DRAINAGE CALCULATIONS

Site Address: **Former Mill, Saville Road,
Skelmanthorpe**

Project Number: **21374**

Reference (Revision): **CAL01 (D)**

R18B 01 2270 Headwall
GMS Sloped Grating
V Notch Weir Wall

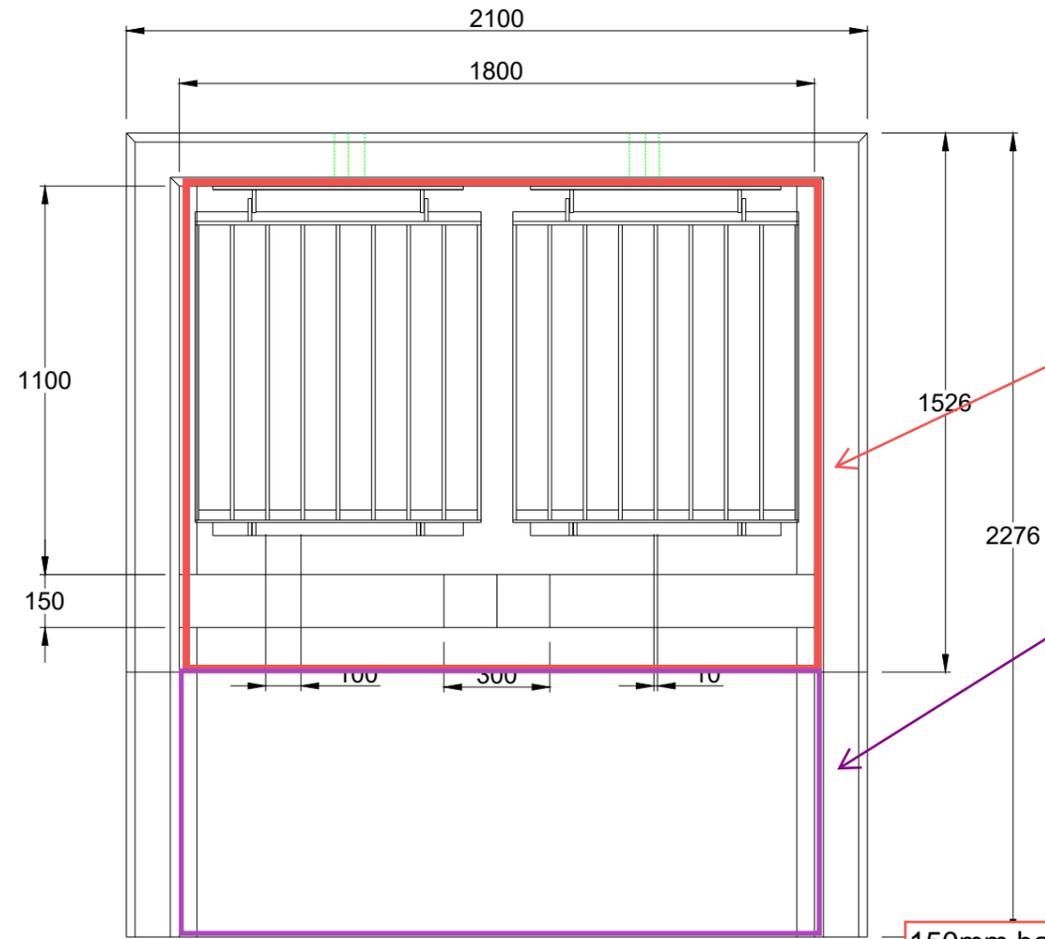
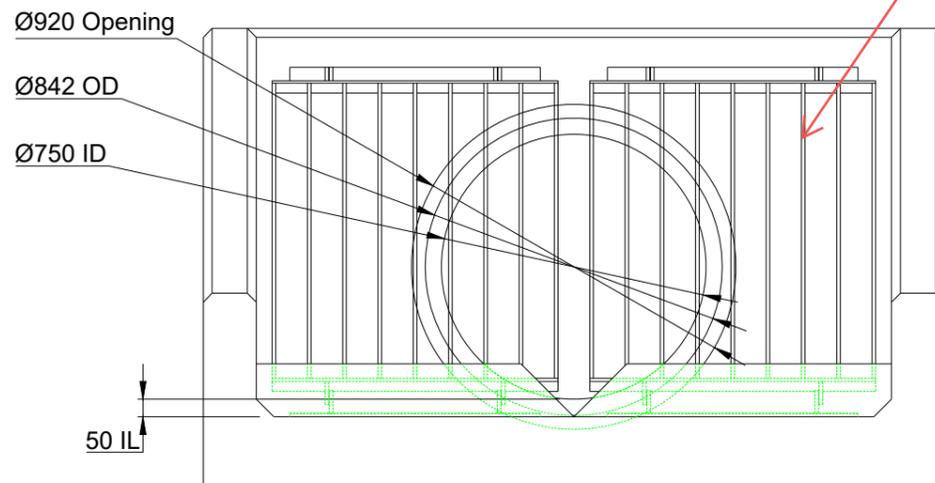
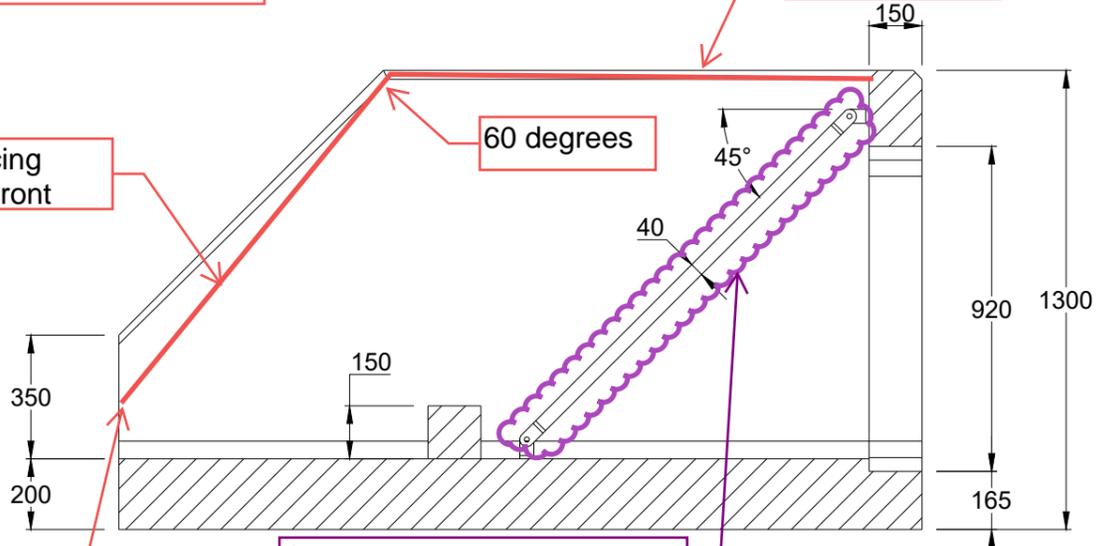
150mm bar spacing to be incorporated at front

75mm bar spacing on top

Bar spacing 150mm front

60 degrees

Terminates here to leave 150mm gap between bottom of grill and top of apron

Can this section be reused and adapted to be the front section of trash screen.

V notch weir wall

- 150mm clearance on vertical bar spacing on sloped grating.
- Sloped grating at front will be at 60-degree angle.
- Sloped grating will have 150mm clearance from bottom of grating to top of apron
- Landing section will need incorporating on top of weir wall headwall and be capable of withstanding pedestrian loading for maintenance
- Landing section will have 75mm bar spacing

SFA15B Headwall
400 x 300mm Toe
Stepped Baffle Block, 3 Sided Kee Klamp
SFA1 750 Outfall Safety Grille

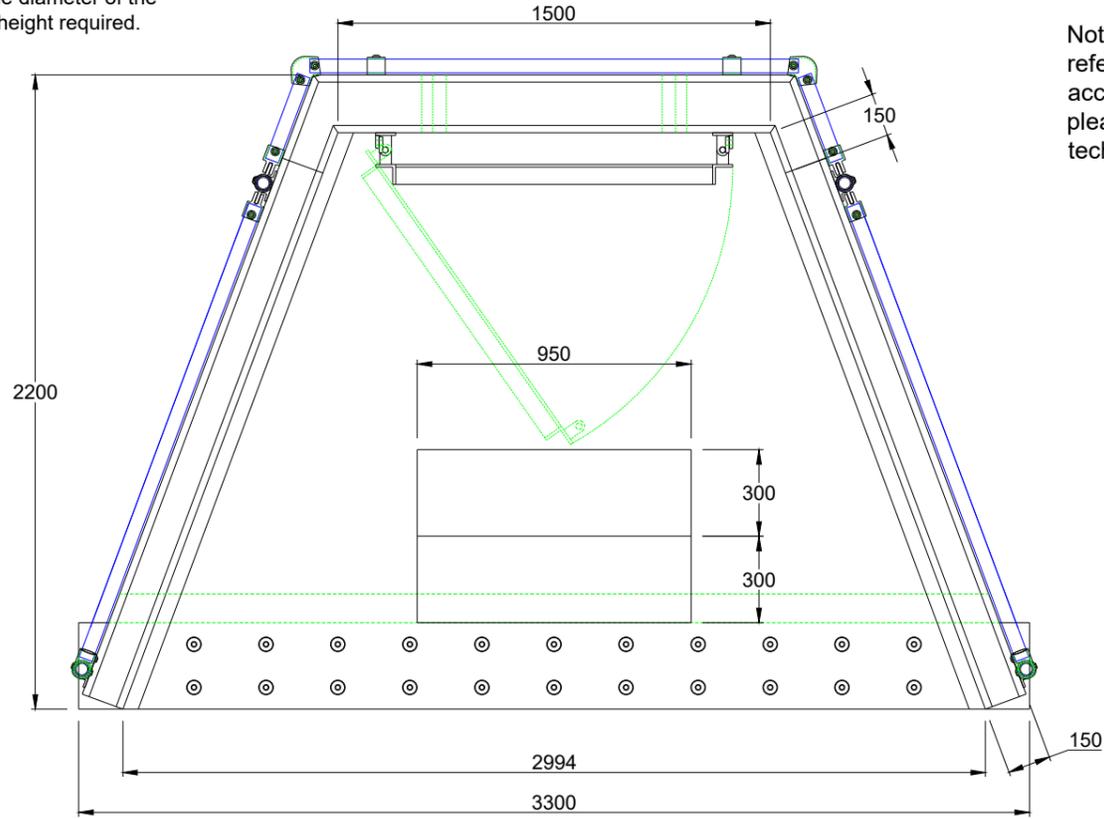
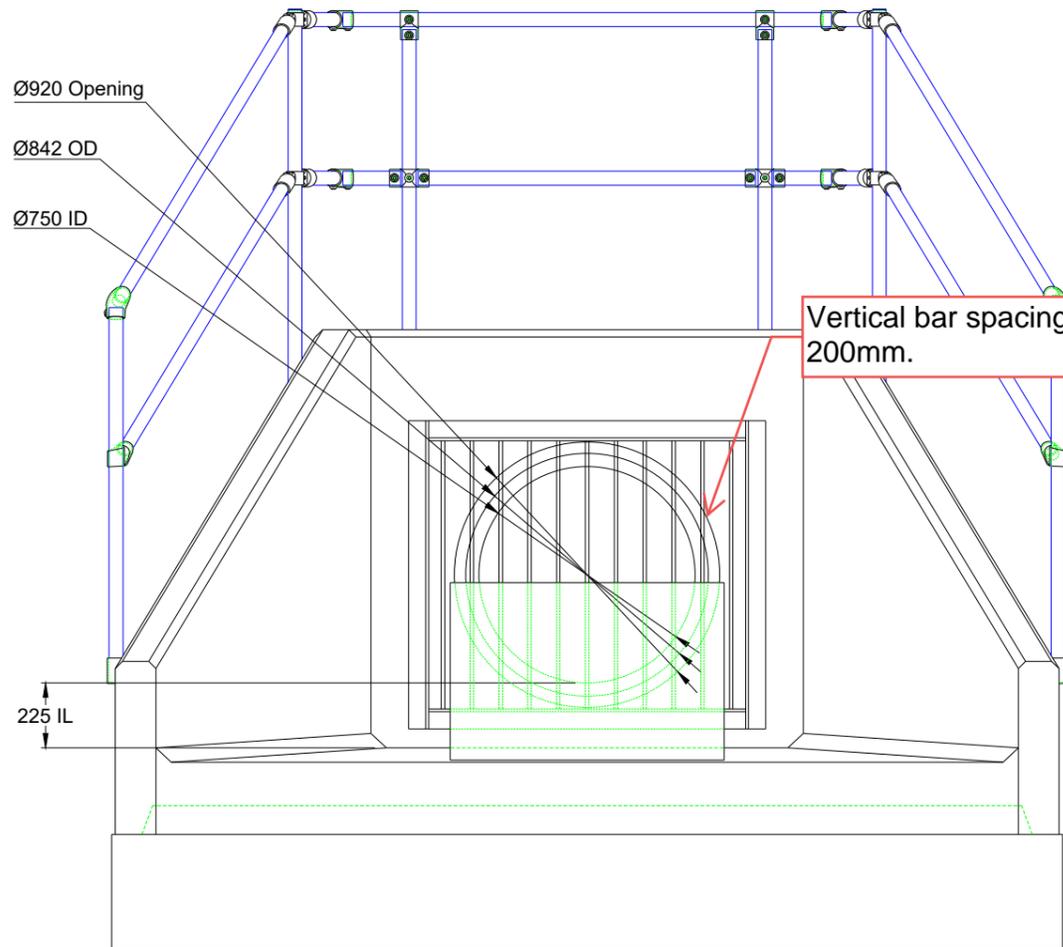
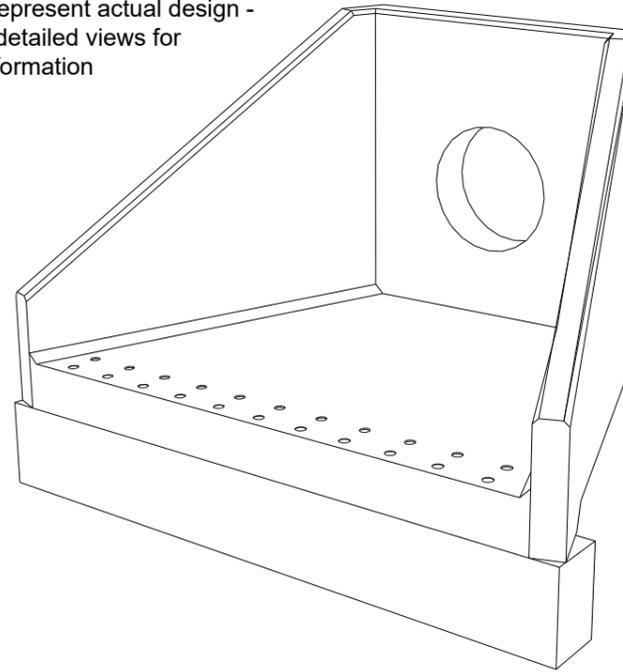
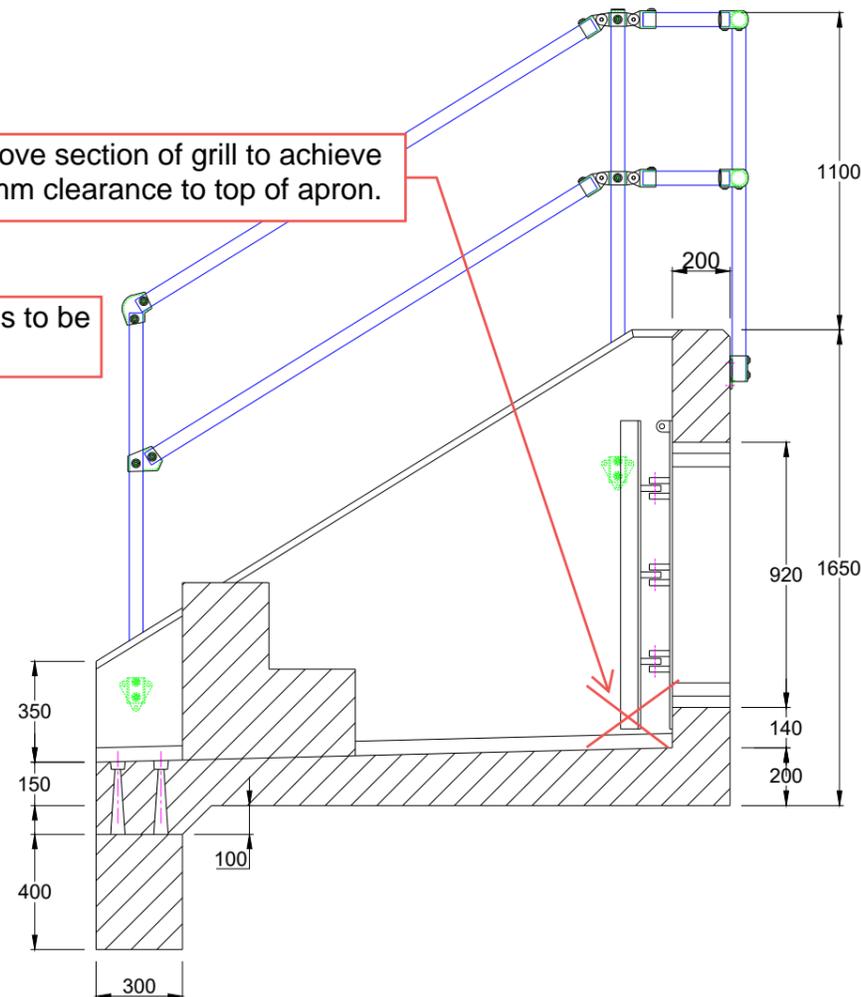
Remove section of grill to achieve 150mm clearance to top of apron.

Site Outfall Headwall

- Outfall grill has been adjusted for 200mm vertical bar spacing
- Outfall grill has been adjusted for 150mm clearance from bottom of outfall grill to top of apron
